Product Change Notice

- Products : Samsung 2835 LED series
- Change : Addition of manufacturing site
- Remark : Effective from December, 2021

Summary

6-4-2. Reliability for 283B+

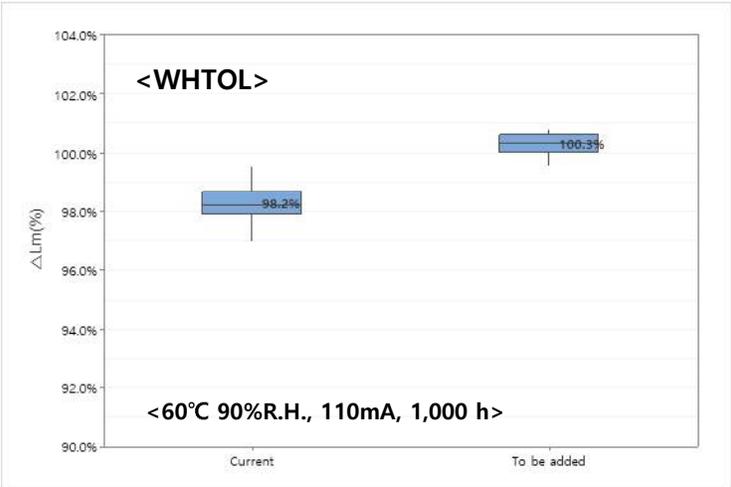
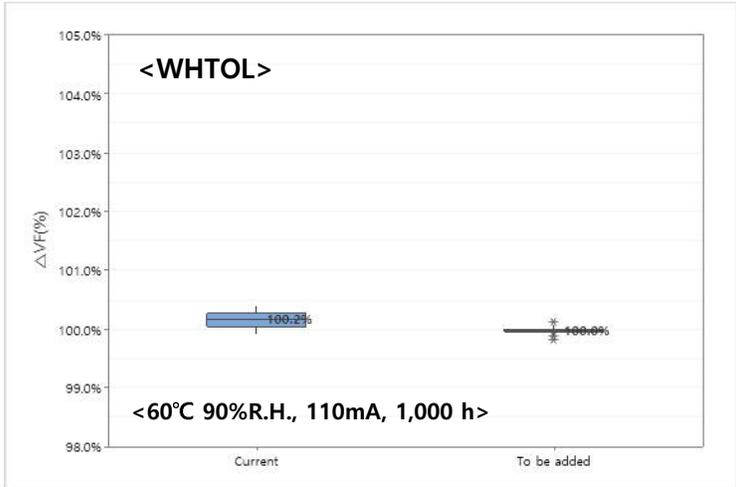
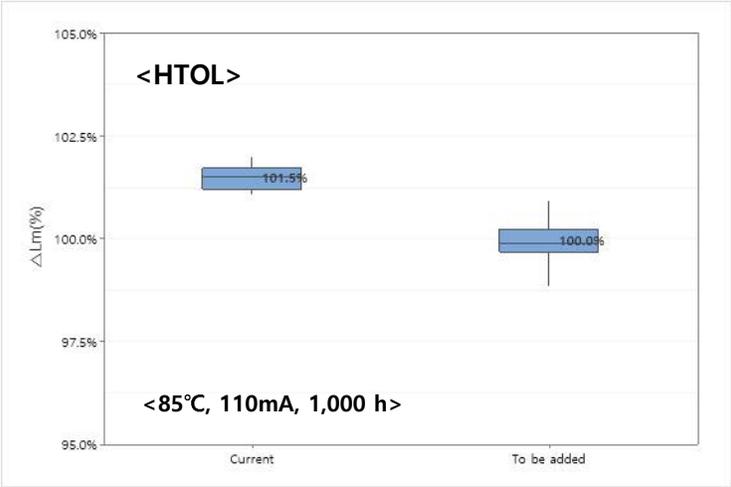
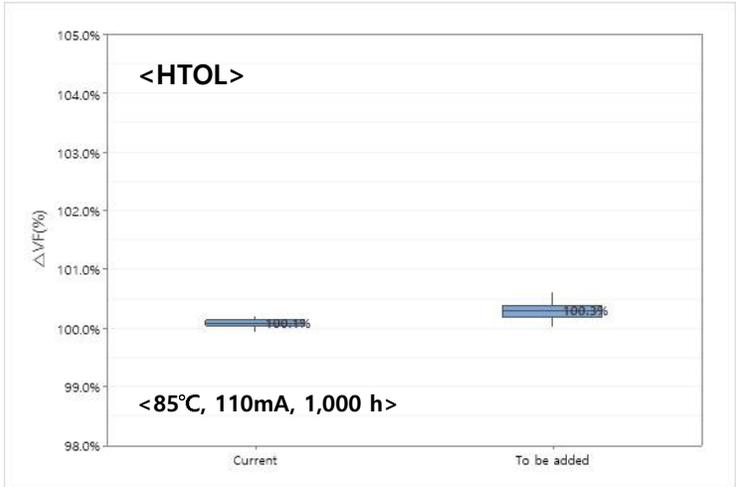
● Passed all criteria in the specifications
